INDEPENDENT REIVEW REPORT

**EXCAVATION PROJECT,
BLOCK 20 MISSISSIPPI CANYON AREA, GULF OF MEXICO**

**to
Taylor Energy Company
New Orleans, Louisiana**

March 1, 2008

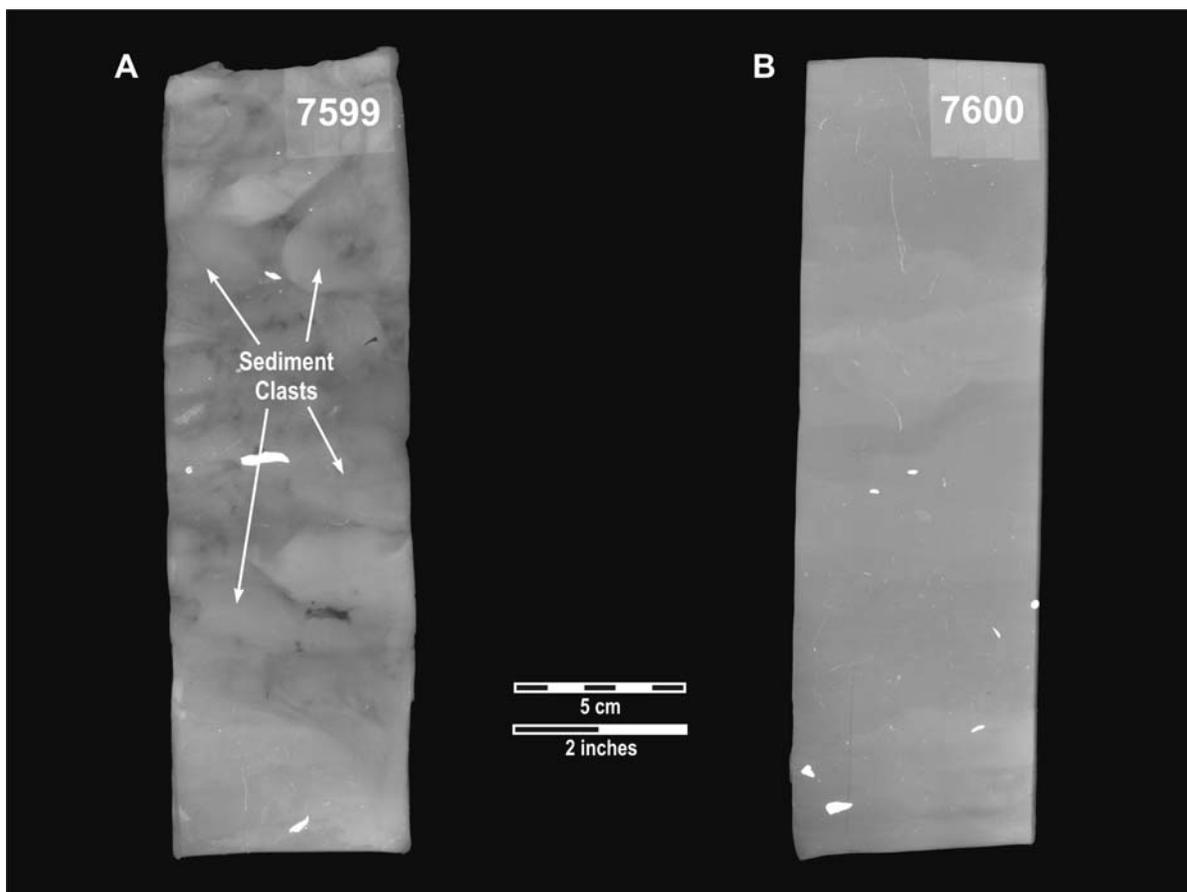
The debris flow deposits, are identified as being 25 feet thick in the FMFR. Data from Boring 2 (X-ray radiographs) indicate that these deposits are found as deep as 178 feet below the mudline (Figure 4). Although it is true that the debris flow deposits do not occur continuously throughout the interval 130-178 feet (an interval of 48 feet), a thin debris flow deposit does occur at a stratigraphic depth of 178 feet and this horizon could function as a slide plane if deep sediment instability processes are reactivated at this site. Figure 4 illustrates the X-ray radiographs of the debris flow deposit at the 178 foot depth and the sediment beneath it which

has internal structures and inclusions suggesting relatively slow deposition. It is clear that the debris flow clasts from all horizons are derived from erosion of preexisting outer shelf-slope deposits, especially in the interval 130-164 feet (interval thickness of 34 feet). Radiocarbon dating (AMS) in the middle of the 34 foot interval (samples at 141-141.8 feet) dated at 6,480 +/- 40 years BP. Clasts in this sample are from hemipelagic sediments deposited as the shelf was flooded following the latest Pleistocene glacial maximum and before the modern Mississippi River was delivering much sediment to the site. Dates of 21,390 +/- 80 years BP and 22,600 +/- 110 years BP acquired from nondeformed sediments that bracket the thin debris flow deposit at a depth of 178 feet suggest that the process or processes responsible for this thin unit are decoupled from debris flow deposits in the 130-164 foot interval. Therefore, mudflow sediments and associated underlying debris flow units that overlie older shelf-slope transition deposits end at a depth of 164 feet in Boring 2.

Thin debris flow unit at the 173 foot stratigraphic horizon indicate that this debris flow deposit is not associated with Holocene deposition. The data from Boring 2 show a slight reduction in shear strength in this interval. Sediment type and geotechnical data suggest that this horizon could function as a slide plane if a mudslide eroded through the uppermost shelf-slope transition deposits to near the 173 foot level.

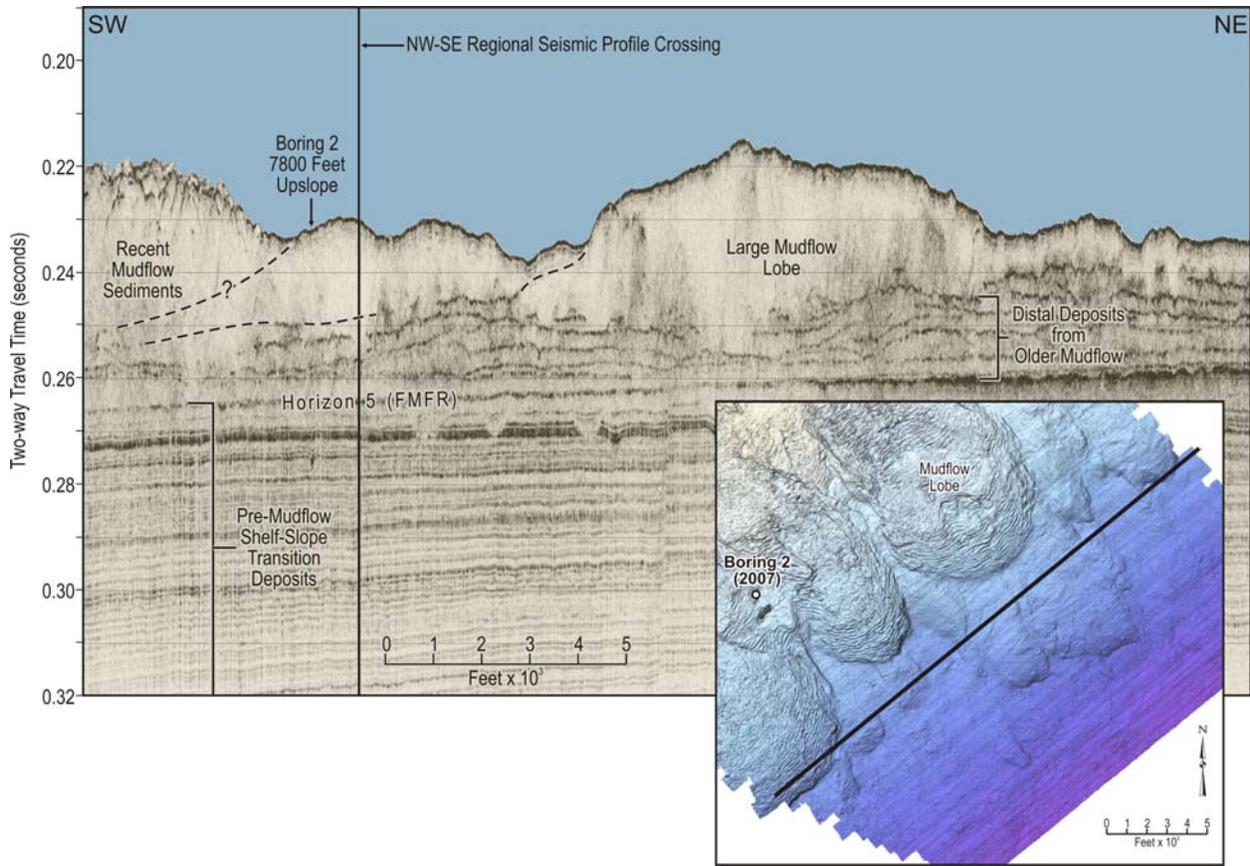
The Figure 5 profile was selected for illustration purposes because it clearly shows the stacking pattern of both the distal “toes” of older mudflow deposits and the thicker acoustically opaque younger lobes. The rough-appearing surface of the youngest lobe at the SW side of the profile has parabolic acoustic returns derived from irregularities (blocks and pressure ridges) at the surface of the lobe. Post-mudflow deposition has filled in irregularities on lobes to the NE. Beneath the thick acoustically opaque mudflow deposits are the offset and stacked thinner units which represent the distal “toes” of mudflow deposits separated by strong reflectors. The acoustic impedance difference between the mudflow sediment and these thin high amplitude reflectors is the difference in properties between remolded delta-front mud and thin silt-rich turbid flow deposits mixed with hemipelagic sediments containing abundant calcareous microfossil tests.

The point of illustrating the compensational stacking patterns of mudflow lobes and the variations in sediment types is to emphasize the potential lateral and vertical variability in sediment types and their corresponding geotechnical properties. Whatever else is true of composite mudflow deposits that dominate the outer shelf and upper slope opposite the modern Mississippi River Delta, they do not describe “layer cake” geology. These are complex interfingering deposits that range from highly gassy and thoroughly remolded clays and silty-clays to true hemipelagic sediments with a substantial content of shell material (mostly from pelagic foraminifera) that separate mudflow units (Roberts, 1980). Occasionally, localized sand-sized sediments are encountered, but not often. The stratigraphic architecture illustrated in the seismic profile of Figure 5 strongly suggests that assumptions of lateral continuity of geotechnical properties cannot be supported. Specifically, the “weak layers” determined from Borings 2 and 8 cannot be projected as “geologic events” that are present as consistent layers throughout the sediment excavation project area. Clearly, weak sediments are characteristic of both mudflow lobe and gully deposits. However, the stacking patterns of sediments of different engineering properties affects slope stability. The natural lateral variability of depositional units and their associated geotechnical properties has profound implications on modeling the stability of a large-scale sediment excavation, the subject of the Fugro-McClelland feasibility study.

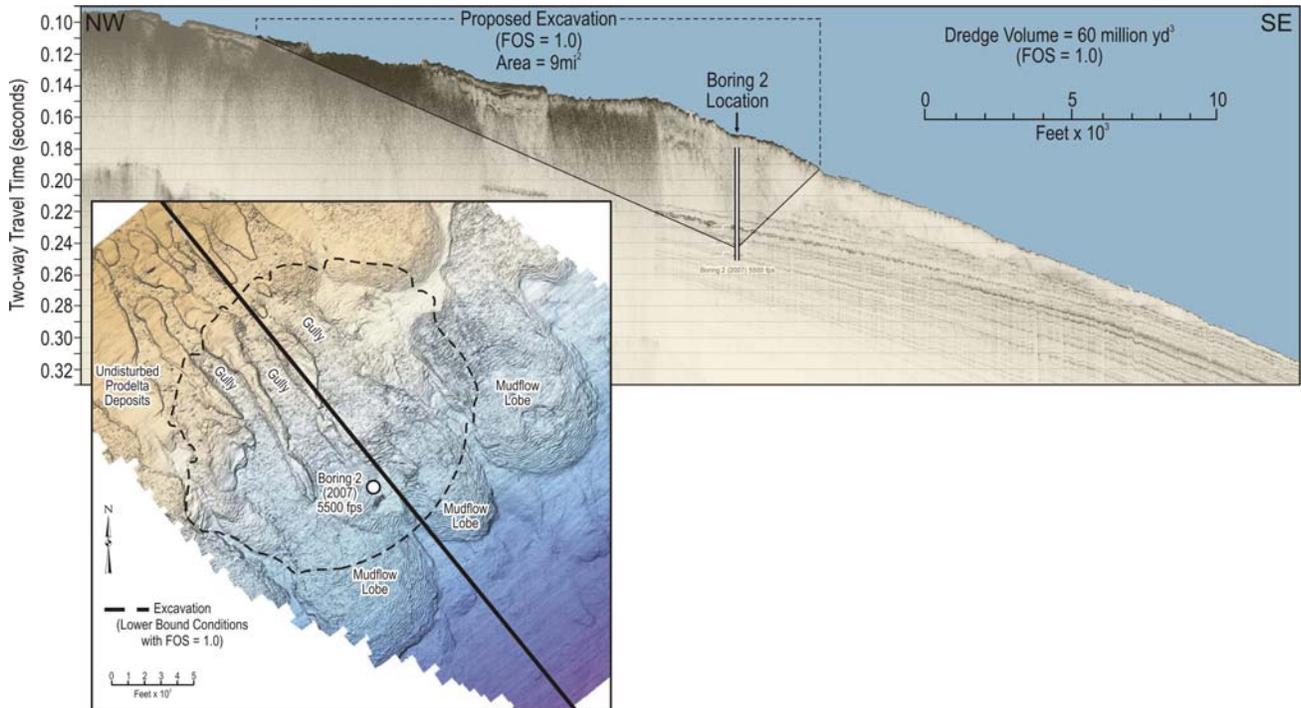
Using the lower bound case for the slope stability analysis with the marginally stable slope FOS = 1.0, the slope of the excavation wall north of the well bay was determined to be 1.3°. This value is almost three times the 0.5° slope of the natural delta-front where numerous slope failures occur. As both Figures 5 and 6 clearly demonstrate, the excavation would extend beyond the outer shelf-upper slope mudflow lobes into mid-shelf mudflow gullies and islands of undisturbed delta-front sediment. Upslope projections of the excavation (FMFR) indicate that 5

mudflow gullies and 4 islands of undisturbed sediment would be encountered. The gullies are transport routes that function as the sediment feeder systems for the mudflow lobes at the MC 20 site and adjacent to it. Gullies contain unstable sediment and a seabed profile down any given gully will describe a series of breaks in slope that represent potential points of instability along the transport route (Roberts et al., 1980). No geotechnical data were acquired from the gullies. However, it is highly probable that sediments of equivalent or even lower shear strength than the lower bound value from the mudflow in the well bay area could be encountered in the gullies.

The undisturbed islands of seafloor appear “smooth” on the multibeam image of Figure 2 and stratified in profile view (Figure 6). These areas are composed of relatively undisturbed delta-front sediments that have been deposited over older mudflow lobes and gullies. That is, they are thin wedges of prodelta clay and silty clay deposited over weak older remolded deposits as the entire delta-front progrades seaward. Since the modern Mississippi River Delta is only 600-800 years old (Coleman et al., 1980), all of the sediments in the project area above Horizon 5 (FMFR) are probably less than 400 years old. The fact that all these sediments are young suggests that they are all highly underconsolidated, exhibit excess pore pressures, and consequently have low shear strength profiles because of rapid deposition and the fact that they are generally fine grained (Coleman et al., 1980; Roberts et al., 1980). Removing these

sediments by dredging to a design slope of 1.3° is probably not feasible without continued wall failures. Undercutting the slabs of “undisturbed” sediments would no doubt initiate retrogressive slumping as occurs on the upper delta-front at the heads of gully systems.
